Number	Section	Page	Topic	WSP Comment	SYSTRA Response
1	2.3	4	Baseline land use	"It would be helpful if clarification could be provided as to the reasons behind these differences, particularly given that on a zone by zone basis, almost a quarter of the 69 zones with non-zero growth have significant differences in their land use assumptions, with zone 252 showing the biggest difference"	The land use totals were specified to us by Eastleigh Brough Council on 10/01/2018 and account for the evolution of the planning data since the earlier scenario.
2	2.3	5	Do Something land use	"This figure exceeds the Eastleigh Local Plan target of 14,580 dwellings between 2016 and 2036 by 2,850 dwellings, not by 2,392 dwellings as stated in Paragraph 11.2.3 of Transport Assessment Part 1. Therefore, clarification is requested to ascertain which figure is correct"	The stated figure of 2,392 dwellings is correct as the Baseline which consists of 8,897 dwellings includes 458 completions. This point was clarified and TA Part 1 reissued. As above, all land use totals were specified to SYSTRA by EBC and provided to SYSTRA on 10/10/2018.

DS2 Flows showing rerouting for an exemplary OD pair (from zone 217 to zone 341). All traffic that used M3 J12 in the Baseline is now rerouting.

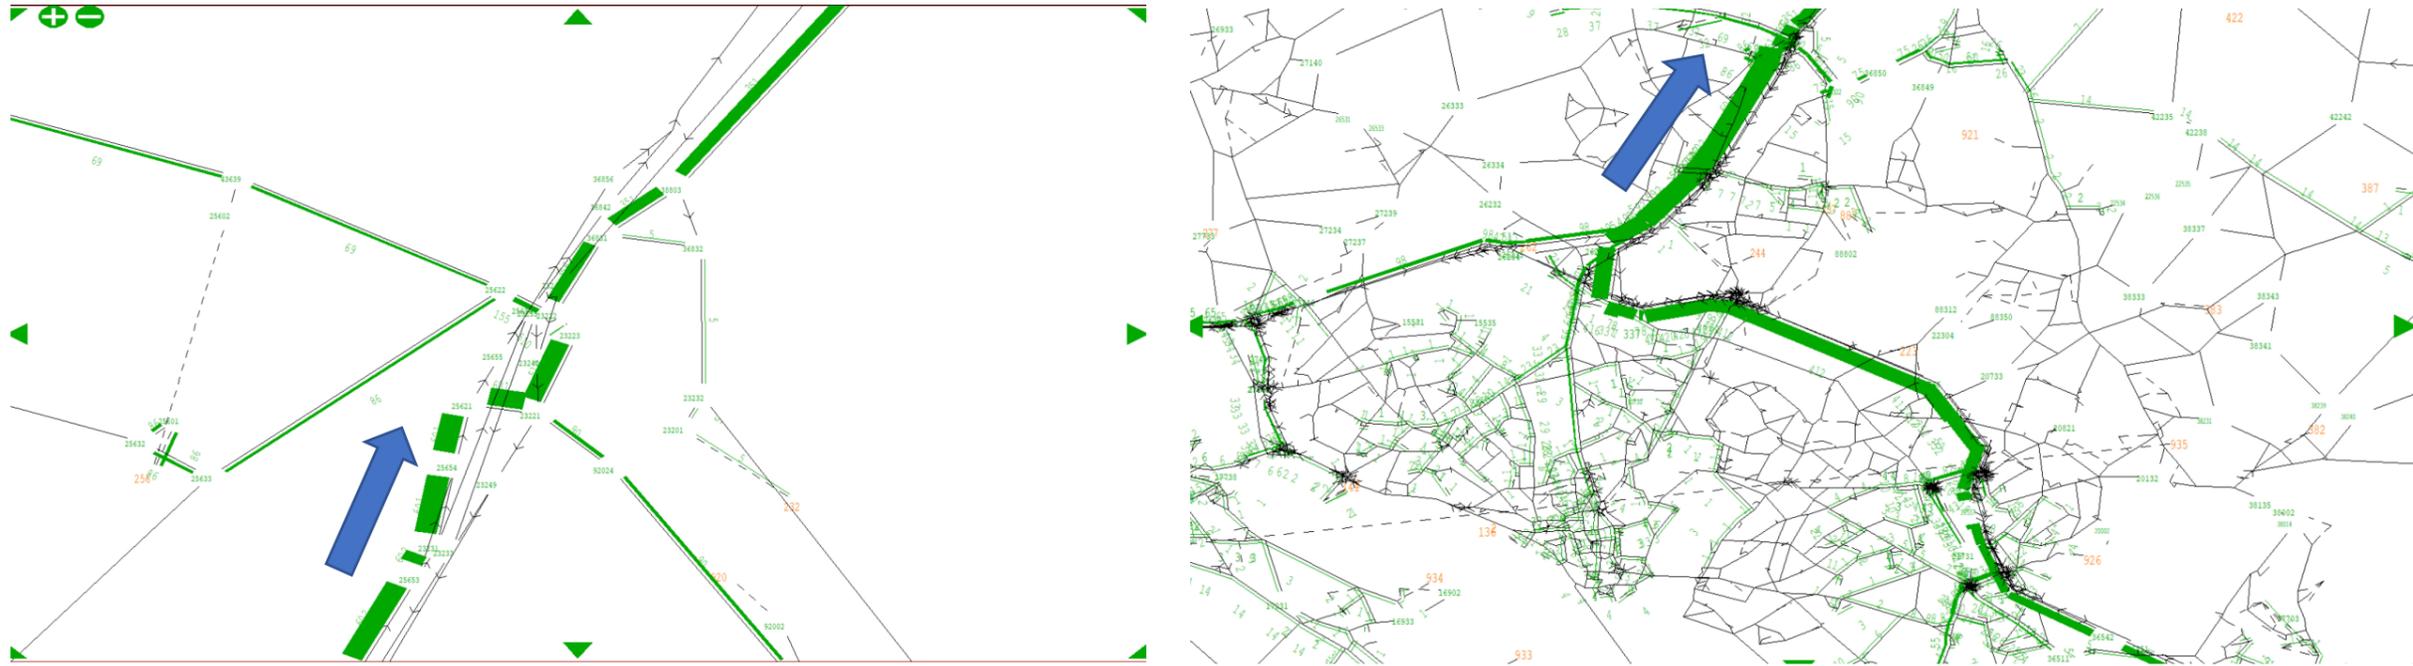
14	3.3	12	M3 J12 Allbrook	"Paragraphs 6.5.40 to 6.5.43 of Transport Assessment Part 2 provided some analysis of this junction performance data, however, <b>much of this analysis was found to be inconsistent with the data presented</b> in Tables 36 and 37 and therefore requires amendment."	This observation is correct; the text refers to an incorrect arm. Text has been amended in TA Part 2 version 3.1.
15	3.3	12	M3 J12 Allbrook	"On the A335 motorway bridge approach, flows during the AM peak significantly decrease from 599pcu to just 30pcu. Paragraph 6.5.42 of Transport Assessment Part 2 explains that this decrease is due to increased delays at the adjacent M3 J12 Northbound Roundabout in the Do-Something scenario, causing traffic to divert away from the junction onto alternative routes. Given the amount of traffic predicted by the model to divert away from the northbound M3 prior to Junction 12, <b>further evidence is required to help understand the full impact on M3 J12 and the</b>	SYSTRA has undertaken a Select Link Analysis on the A335 motorway bridge approach in the Baseline scenario. A number of O-D pairs using this link have been identified. These O-D pairs have then been analysed with flows from the Do Something 2 scenario. This analysis has shown strategic rerouting away from M3 J12 onto Allington Lane and the B3354 corridor through Boorley Green and Horton Heath. For example, traffic originating in zone 271 close to Windhover Roundabout with zone 434 as a destination (Shawford/Otterbourne) takes the M3 in the Baseline and leaves the motorway at J12. However, in the DS2 scenario all traffic of this OD pair is

wider Strategic and Local Road Network of this very large and surprising flow change, to establish if this rerouting and its associated impacts are considered realistic and acceptable.”	rerouting. As can be seen from the plots on page 5, 92% of traffic are using Allington Lane and 8% Burnetts Lane/Botley Road in the Do Something 2 scenario.
16	3.3	13	M3 J12 Allbrook	“It is recommended that the junction coding, in particular the gap acceptance values and saturation flows, are reviewed at this junction to ensure accuracy and consistency. It is considered that errors may exist in both scenarios with the Do-Something coding potentially allowing too little capacity at the junction leading to flow reductions on the M3 and the Do-More coding potentially allowing too much capacity at this roundabout.”	Highway coding throughout the SRTM is standardised and consistent based on junction type, number of approach arms and provision of localised flaring. Gap acceptance values are applied globally. Coding at this particular junction has been checked and is consistent with the standardised values for this type of junction arrangement.
